Customer	: CU-DAR001 Dart Helicopters Services	Drawing Name	: HELI UTILITY BASKET LH/RH 350/355
Job Number	: 36676		
Estimate Number	: 10208		
P.O. Number	:	Part Number	: D350607043
This Issue	: 1/9/2008 S.O. No. :	Drawing Number	: D350-607 REV F P7-9
Prsht Rev.	: NC	Project Number	: N/A
First Issue	: / / Type : LARGE FAB ASSY	Drawing Revision	: F
Previous Run	: 36675	Material	:
Written By	:	Due Date	: 1/31/2008 Qty: 1 Um: Each
Checked & Approved By	: <u>08.01.09</u>		
Comment	: Est Rev:E as Per DSI9318 06-01-24 JLM		
	: Est Rev:F ECN1068 07-12-21 DD

DESIGN <i>CP</i>	DRAWN BY <i>CP</i>	DART AEROSPACE LTD HAWKESBURY, ONTARIO, CANADA	
CHECKED <i>[Signature]</i>	APPROVED <i>[Signature]</i>	DRAWING NO. DSI 9318	REV. A SHEET 1 OF 1
DATE 06.01.06		TITLE WASHER ADDITION	SCALE NTS
A	06.01.06	NEW ISSUE

DART SERVICE INSTRUCTION

TO AMEND INSTALLATION INSTRUCTIONS D350-607 REV. F

Figure 5- Basket Replacement Parts
(D350-607-043 Heli-Utility-Basket™)

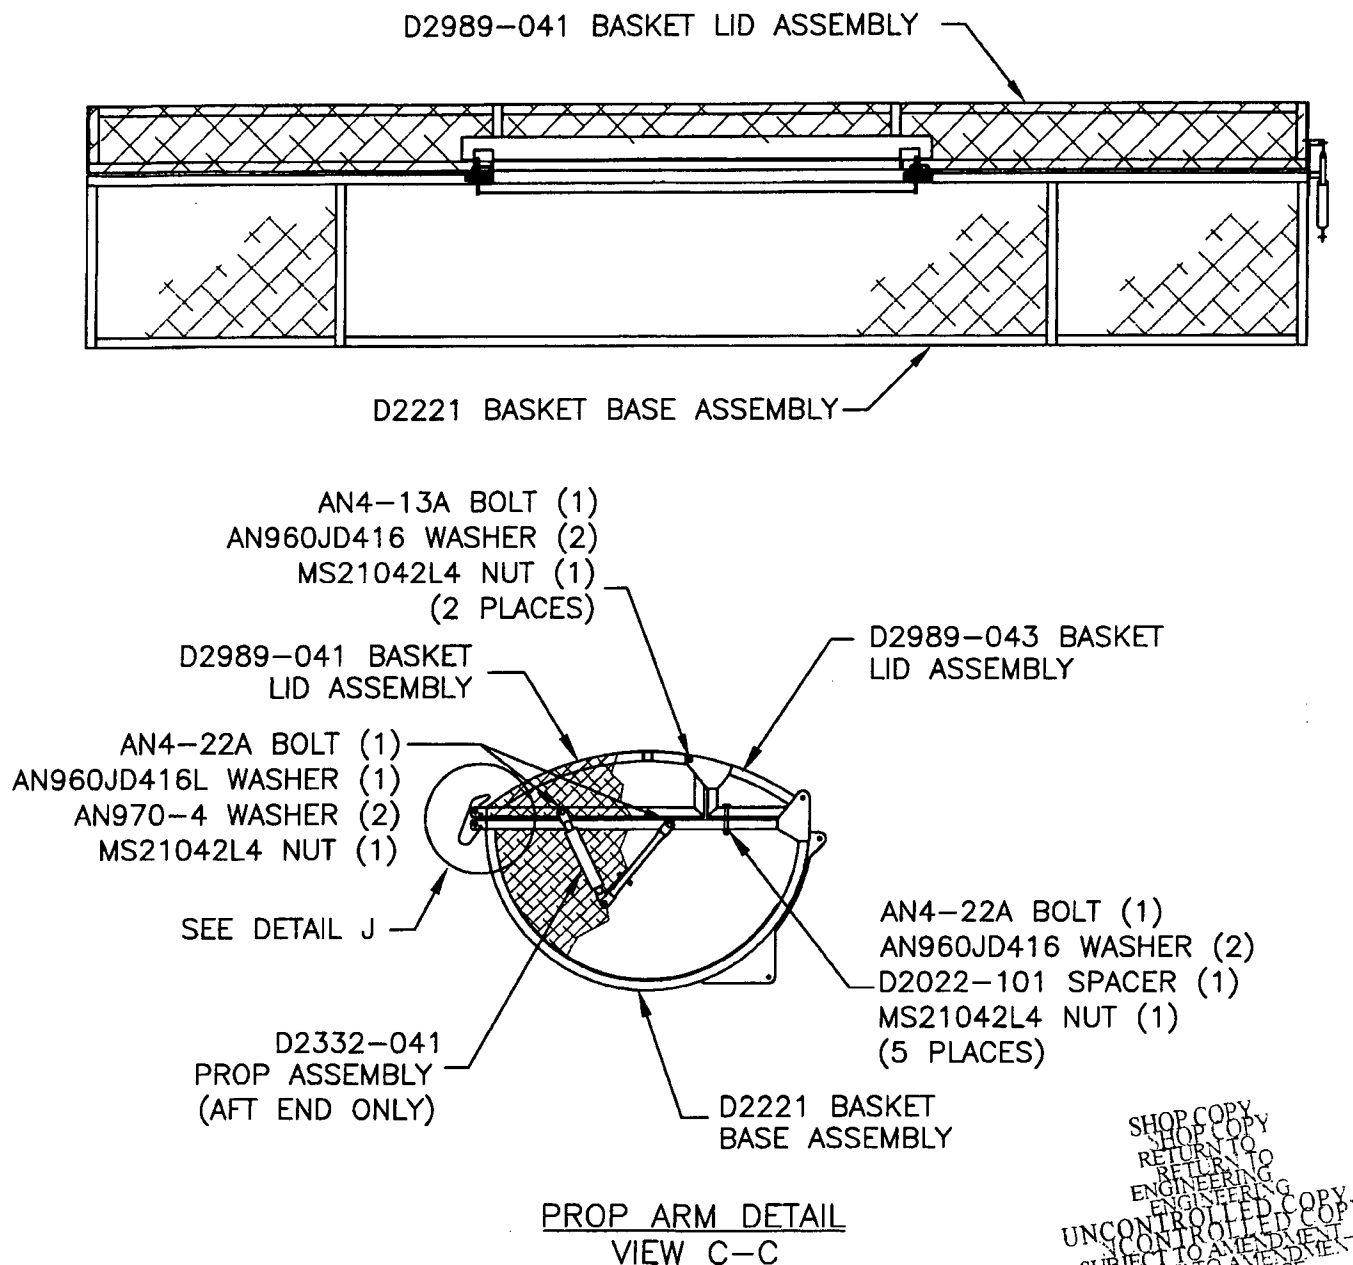
The corrected bolt stackup from Figure 5 of installation instructions D350-607 Rev. F is given below:

AN4-13A BOLT (1)
AN960JD416 WASHER (1)
HINGE PLATE (REF)
NAS1515H4 WASHER (1)
BASKET FRAME (REF)
AN960JD416 WASHER (1)
MS21042L4 NUT (1)
(2 PLACES)

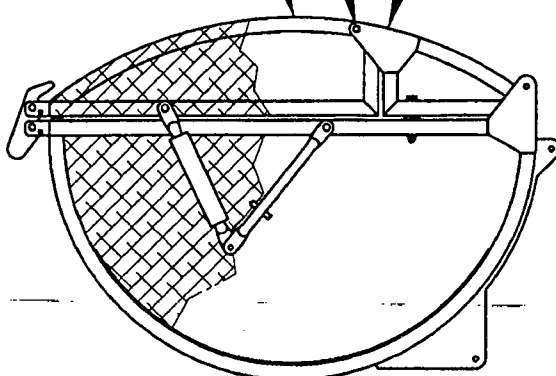
To reduce the possibility of damaging the finish, a **NAS1515H4** washer (2 places) has been added between the hinge plate and basket frame on the **D350-607-043/-047 Heli-Utility-Basket**.
